### Notice of Appeal

NOW COMES, Michael Seaberg, an occupant of 4441 Mountain Road, Stowe, Vermont 05672, and hereby appeals to the Town of Stowe Development Review Board, the approval by the Town of Stowe Zoning Administrator of Project No. Z6088 on December 6, 2019, which authorized VTRE Investments, LLC, located at P.O. BOX 323, Stowe, VT 05672, to "construct a retaining wall and fill and grade within the flood hazard overlay district" at 4409 Mountain Road, Stowe, VT 05672.

Permit Z-6088  
 Application Date 8/19/2019  
 Physical Location 4409 MOUNTAIN RD  
 Map ID 11-107.000 Tax ID 26021  
 Project Description CONSTRUCT RETAINING WALL; FILL AND GRADE WITHIN FLOOD HAZARD OVERLAY DISTRICT- NO DEVELOPMENT WITHIN THE FLOODWAY  
 Owner VTRE INVESTMENTS LLC  
 Applicant/Contact VTRE INVESTMENTS LLC  
 Applicant Address PO BOX 323  
 STOWE VT 05672

**SITE PLAN**  
**VTRE INVESTMENTS, LLC**  
FOR FILL IN FLOOD PLAIN  
4409 MOUNTAIN ROAD STOWE, VT

**SITE PLAN**  
**VTRE INVESTMENTS, LLC**  
 4409 MOUNTAIN ROAD HOUSE REMOVAL & GRADING  
 4409 MOUNTAIN ROAD STOWE, VT

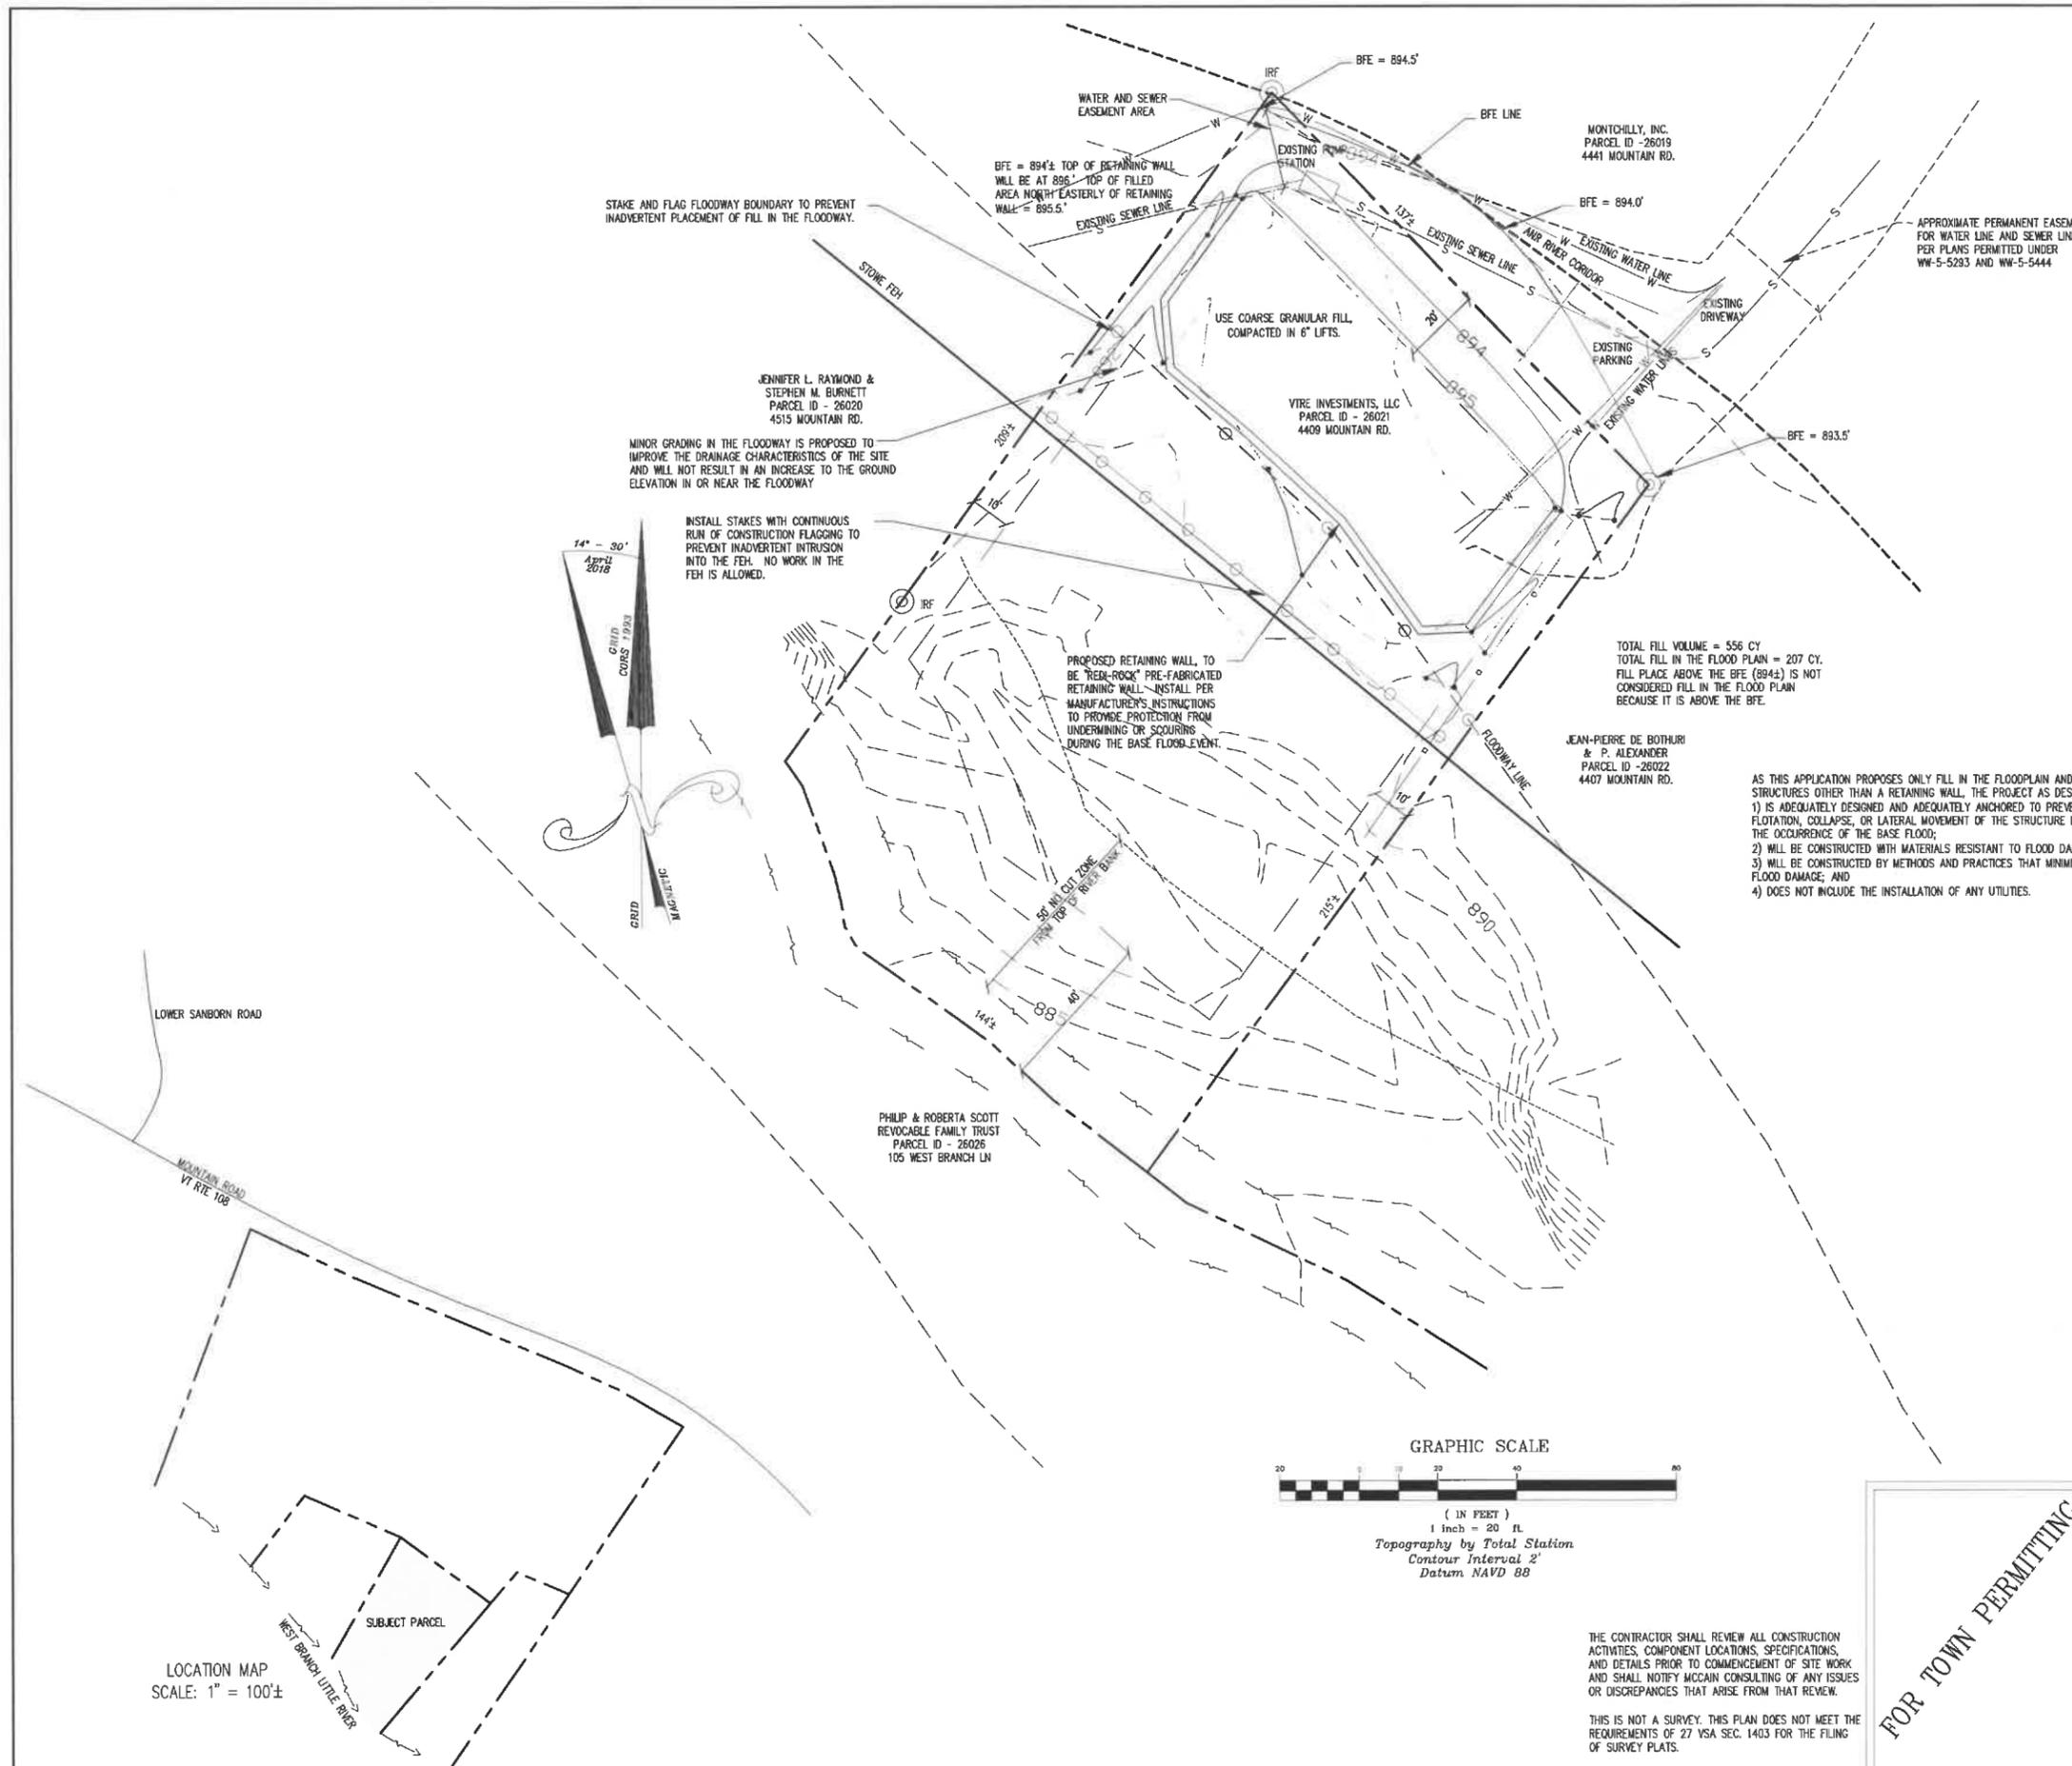
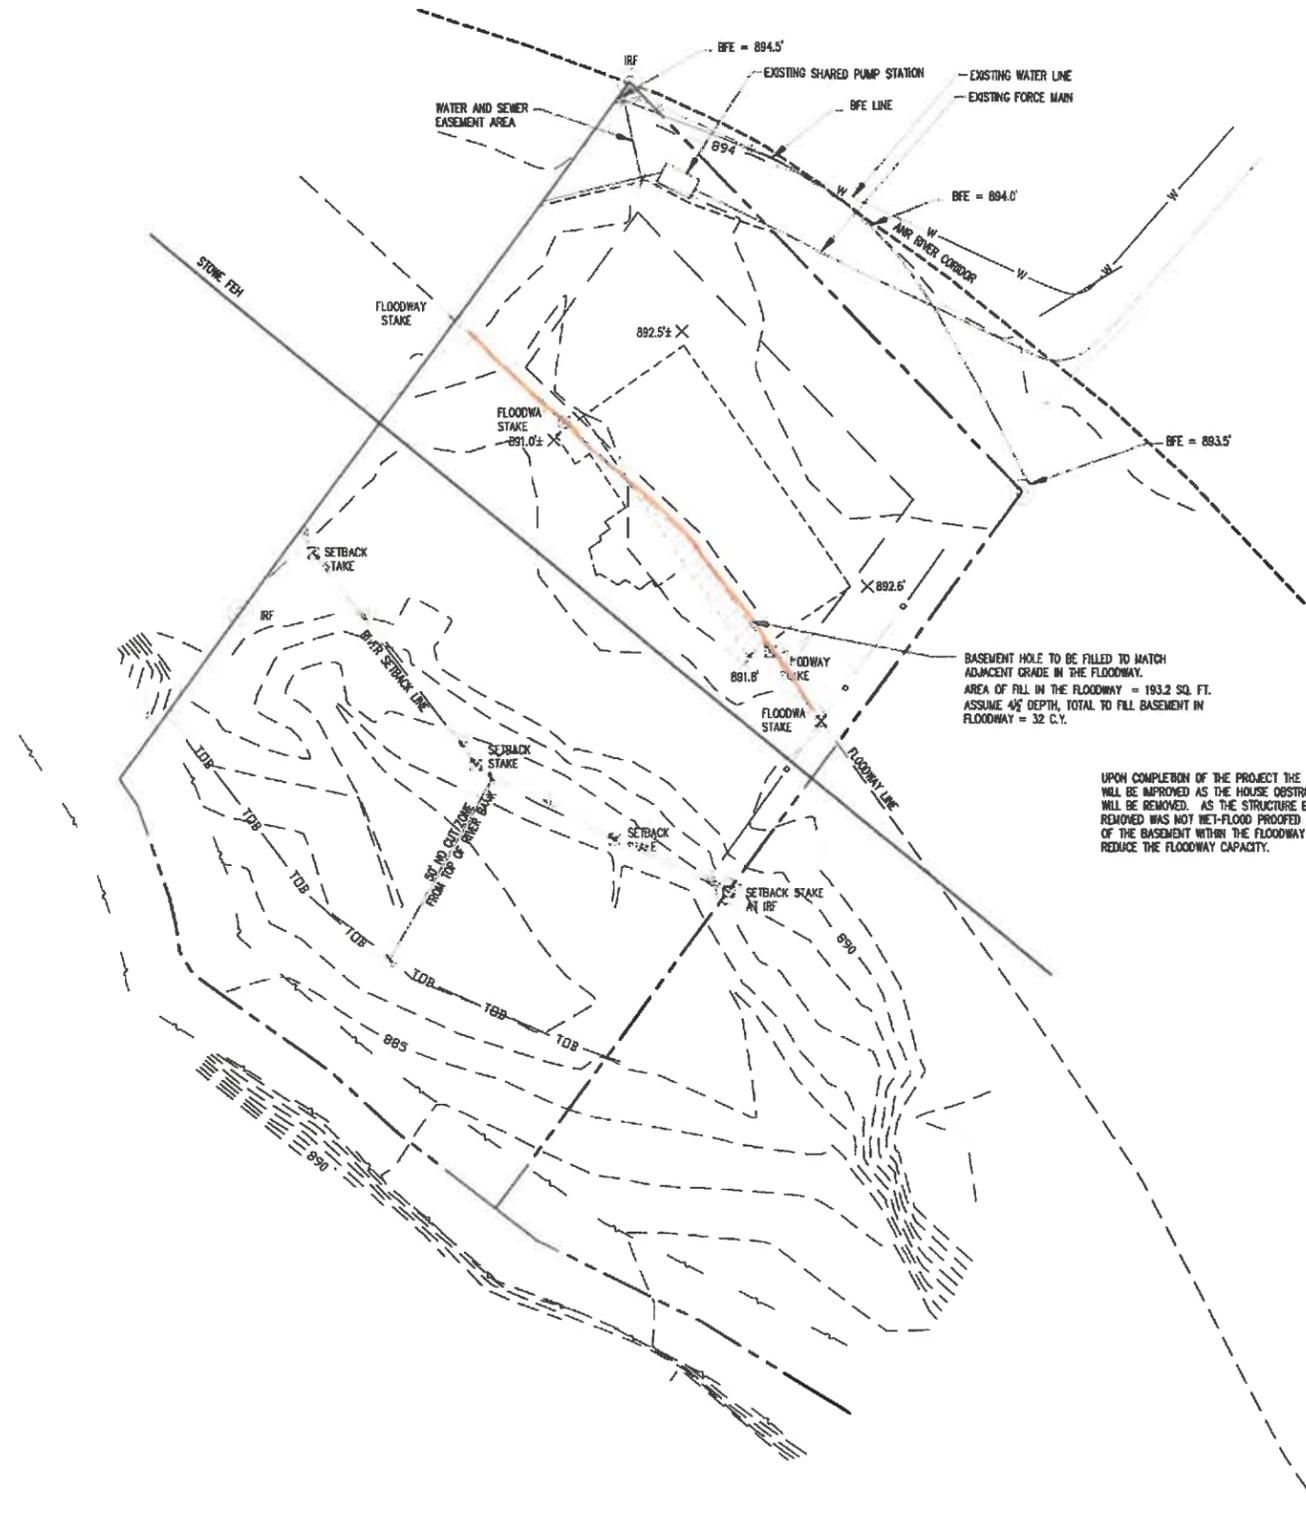
I have reviewed the proposal for the demolition of the existing house at 4409 Mountain Road. This is a site where I had met with the applicant contact Nick Lizotte & his consultant with Rich last summer to discuss renovation and redevelopment options for this site. As you mention below and as written in the application, the current proposal is simply for the demolition of the existing home on the site. I agree that the home is not located in the Town's FEH, and that it is located in the FEMA Special Flood Hazard Area Zone AE (the FEMA mapped floodplain), as well as a very small portion of the home located within the FEMA floodway. The FEMA floodway is a more restrictive part of the floodplain where the minimum FEMA requirements prohibit any new encroachment unless it can be demonstrated that there is no change in flood heights (0.00').

For this particular proposal, there is no new proposed encroachment but rather a removal of an existing encroachment. The requirement for a development within the regulatory floodway to provide hydrologic & hydraulic (H&H) analyses in Section 7.7(1)(A) of the Town of Stowe Zoning Regulations (effective date 7/3/17) comes from a FEMA standard that is intended to assess the impacts from a new above-ground encroachment on flood heights. New above ground encroachments can result in increasing flood heights by redirecting flood flows or displacing flood water within the floodplain. The removal of the existing home at this site would not result in increasing flood heights because the encroachment that displaced flood water is proposed to be removed. Also, although there is an existing basement that will be filled in with the removal of the home, there would not be any expected increase in flood heights from the filling of the basement as long as the basement is filled to match the surrounding existing grade as proposed on the applicant's site plan prepared by McCain Consulting. VTDEC would not expect an applicant to provide a no-rise analysis for the removal of a floodway encroachment such as this house.

The basement of the existing home would not be expected to provide any relief to flood heights since it does not allow floodwater to flow across the floodplain. As is mentioned on the applicant's site plan prepared by McCain Consulting, the basement area has *not* been designed to be wet-floodproofed. Wet-floodproofing means that a space has been designed to allow for water to flow into and out of the space automatically during a flood, and that no part of that space is completely below grade. If the space is completely below grade on all four sides, then the water could get into the space but could not flow back out again. This means that the water is stored in a below-grade basement space rather than allow for water to be conveyed (or pass through) the space. Although a basement would fill up and store some small volume of floodwater, that volume is minimal in comparison to the exponentially larger volume of water flowing across that area of the flood plain over the course of a FEMA-mapped base flood (the 1% annual chance flood, commonly known as the 100-year flood event). It is because of the incredibly small amount of storage in building basements that those basements are not included in the models that FEMA makes to study floods. Those FEMA models do, however, assess the impacts of water having to go around a building or other infrastructure, since there is an impact to flood heights when water is diverted around a building or encroachment such as fill.

Therefore, if the home is removed from the site as is currently proposed, it would appear to meet minimum National Flood Insurance Program (NFIP) requirements and would not be expected to create any rise in flood heights. I would recommend that the Stowe Development Review Board require the applicant to have the floodway boundary staked out on the site during construction in order to ensure that the proposed backfilling and grading located in the floodway does not result in *raising* the surrounding grade of the home, but rather matches the existing surrounding ground elevations. The site plan proposes to match the grade of the filled in basement hole to the adjacent grade in the floodway. The DRB

should have some sort of documentation that demonstrates that the backfilling, especially within the floodway, is completed as proposed. This could include a plan with spot elevations before & after demolition, or pictures showing specific elevation benchmarks prior to and after construction, etc.

UPON COMPLETION OF THE PROJECT THE FLOODWAY WILL BE IMPROVED AS THE HOUSE OBSTRUCTION WILL BE REMOVED. AS THE STRUCTURE BEING REMOVED WAS NOT WET-FLOOD PROOFED FILLING IN OF THE BASEMENT WITHIN THE FLOODWAY WILL NOT REDUCE THE FLOODWAY CAPACITY.

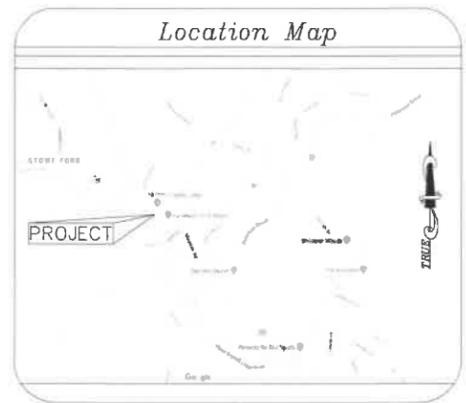
The project is located within the Special Flood Hazard Area (Zone AE)—also called the "floodplain"—according to the FEMA Flood Insurance Rate Maps for Stowe (dated 8/4/2005). It appears the wall and fill are proposed just outside of the floodway, which is the more restrictive part of the floodplain, although the site plan seems to indicate a minor amount of grading within the floodway (see vicinity of 891 and 892 contours). I agree that no work appears to be proposed in Stowe's Fluvial Erosion Hazard (FEH) area.

Both the National Flood Insurance Program and Stowe Flood Hazard District (7.7 (1)A) place high restrictions on the floodway. New encroachments are prohibited in the floodway unless shown not to increase flood heights. The floodway is reserved to freely pass (convey) floodwater, and is the area generally expected to have the highest flood velocities and depths.

To make sure the project does not result in a floodway encroachment, the limits of the floodway should be staked out before construction and checked during construction to assure the ground is not raised in the floodway and the wall does not end up in the floodway. It's unclear if the minor grading I'm noticing in the site plan may be associated with the previously permitted removal of an existing house. I suggest getting confirmation of this from the applicant. Please refer to state floodplain manager Rebecca Pfeiffer's 7/12/2018 review comments for the demolition project (attached). Any areas graded in the floodway should not result in an increase in ground elevations. As with the 2018 proposal, the town is advised to seek documentation that all disturbed areas, especially in and near the floodway, are completed as proposed. Examples of documentation: a site plan with before & after spot elevations, photos showing specific elevation benchmarks prior to and after construction, etc.

Minimum NFIP requirements (44 CFR 60.3(a)(3)) and Stowe Zoning (7.7(2)A) call for the community to assure that "all development shall be reasonably safe from flooding" and "constructed by methods and practices that minimize flood damage." There is one aspect of the application where I suggest the town get a little more information, as part of addressing the above standards. The application information was unclear whether the retaining wall, being so close to the floodway, was designed to withstand the anticipated base flood velocities and depths at that location. To make sure the wall is not undermined and damaged by scour during flooding, DEC Rivers recommends the town request evaluation

of the wall by a professional engineer, with his/her confirmation that the wall is designed to withstand the anticipated base flood conditions noted in the FEMA Flood Insurance Study for Stowe (dated 8/4/2005) at this location.

1. As noted and highlighted below, there appears to be minor grading proposed within the floodway (see 891 and 892 contours). Please provide additional information on the proposed changes. Are they part of the removal of the structure? Are any changes proposed on the river side of the floodway line? A revised site plan showing the outline of the building footprint will help provide context, as well as existing and proposed elevations in that area.
2. As noted and highlighted below, please provide an evaluation of the wall by a professional engineer with confirmation that the wall is designed to withstand the anticipated base flood conditions noted in the FEMA Flood Insurance Study for the Town of Stowe (8/4/2005) at this location.

- Ask him to add to his statement on the site plan about flagging the FEH, or to add a similar statement about the FEMA floodway; i.e. the floodway will be staked to prevent inadvertent work in the floodway.
- Ask him to add to or add a new call out for the Redi-rock wall a statement similar to his email language, i.e. the wall has been designed to be anchored against flood flows ...
- Ask him to add to the statement on fill, or add a new statement regarding the minor grading in the floodway that would only result in the removal of material for drainage and would not result in the placement of new fill or an encroachment in the regulatory floodway.

- Add to the statement on the site plan about flagging the FEH, or to add a similar statement about the FEMA floodway; i.e. the floodway will be staked to prevent inadvertent work in the floodway.
- Add to or add a new call out for the Redi-rock wall a statement similar to your email language, i.e. the wall has been designed to be anchored against flood flows ...
- Add to the statement on fill, or add a new statement regarding the minor grading in the floodway that would only result in the removal of material for drainage and would not result in the placement of new fill or an encroachment in the regulatory floodway.

*I have reviewed technical specifications supplied by the manufacturer for the proposed retaining wall (Redi-Rock) to evaluate the performance of the wall against the anticipated flood conditions outlined in the FEMA Flood Insurance Study (FIS) for Stowe, dated 8/24/2005.*

- *Maximum depth of water = 2.5' (west side of retaining wall, BFE = 894.5')*
- *Velocity of water = 5.5 feet/second*

*Based on the technical bulletin "Analysis of Redi-Rock blocks subject to drag shear force from flowing water", the expected forces on the wall are well within the performance standards for Redi-Rock blocks. In addition, if constructed in accordance with the Redi-Rock installation guide for a typical gravity wall section, the blocks will be capable of providing reasonable resistance to undermining or damage by scouring during the expected flood conditions.*

*The minor grading shown on the plan only involves the removal of a small amount of material to improve the drainage characteristics of the site, and will not result in any increase to the ground elevations in or near the floodway.*

PROPOSED RETAINING WALL TO BE "RED-ROCK" PRE-FABRICATED RETAINING WALL - INSTALL PER MANUFACTURER'S INSTRUCTIONS TO PROVIDE PROTECTION FROM UNDERMINING OR SCOURING DURING THE BASE FLOOD EVENT.

TOTAL FILL VOLUME = 556 CY  
TOTAL FILL IN THE FLOOD PLAN = 207 CY.  
FILL PLACE ABOVE THE BFE (894') IS NOT CONSIDERED FILL IN THE FLOOD PLAN BECAUSE IT IS ABOVE THE BFE.

REVISIONS	EDITS PER FLOOD HAZARD REVIEW
11/26/19	EDITS PER ZONING ADMINISTRATOR REVIEW
08/12/19
